SCHWEIZER SERVICE BULLETIN

DB-015.1*
19 Apr 2006

SUBJECT: MODIFICATION OF CEF 8618M33 LINEAR ACTUATOR

MODELS AFFECTED: 269D and 269D Config. "A" Model helicopters serial numbers 0001 through 0056.

Figure DB-015-1

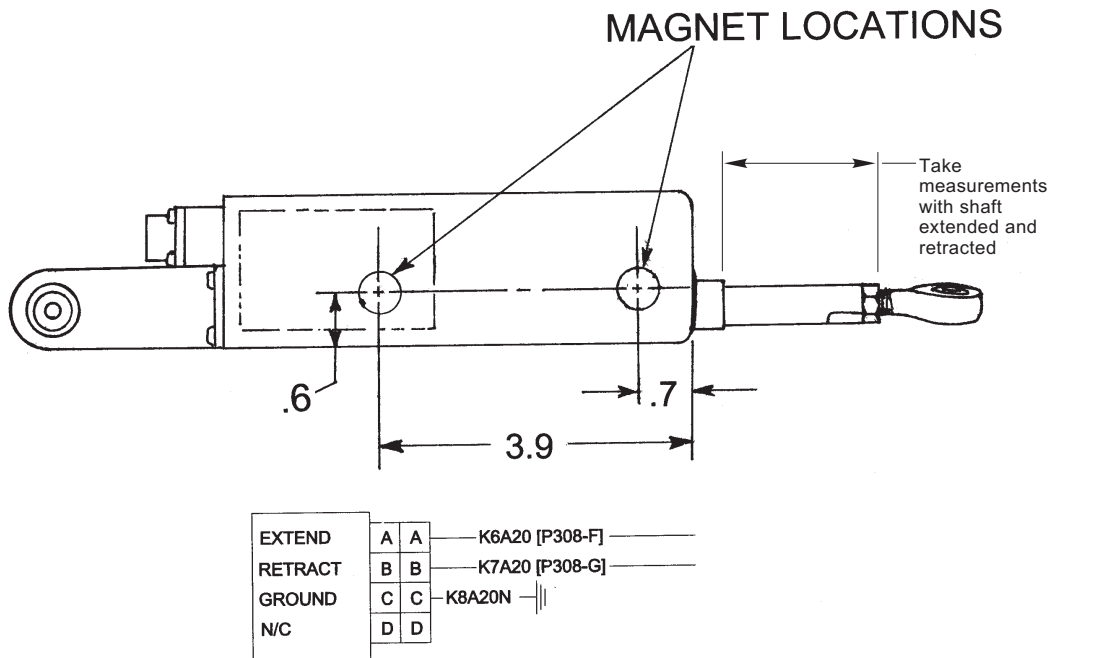
- (3) Place permanent magnet at fixed end in area shown in Figure DB-015-1 on the data plate side and retract actuator shaft until sound from electric motor shows it has stalled.
- (4) Measure length of shaft protruding from actuator and record measurement.
- (5) Place magnet at the opposite end (Fig. DB-015-1) and extend actuator shaft until motor stalls. Measure and record length of shaft protruding from actuator.
- (6) Subtract fully retracted measurement from fully extended measurement. A measurement less than 1.128 inches indicates an unserviceable actuator that must be removed from service before further flight.
- (7) Retract a serviceable actuator to mid range and reinstall trim actuator in accordance with Basic HMI Section 4.
- (8) Record compliance with this periodic inspection in the aircraft records.
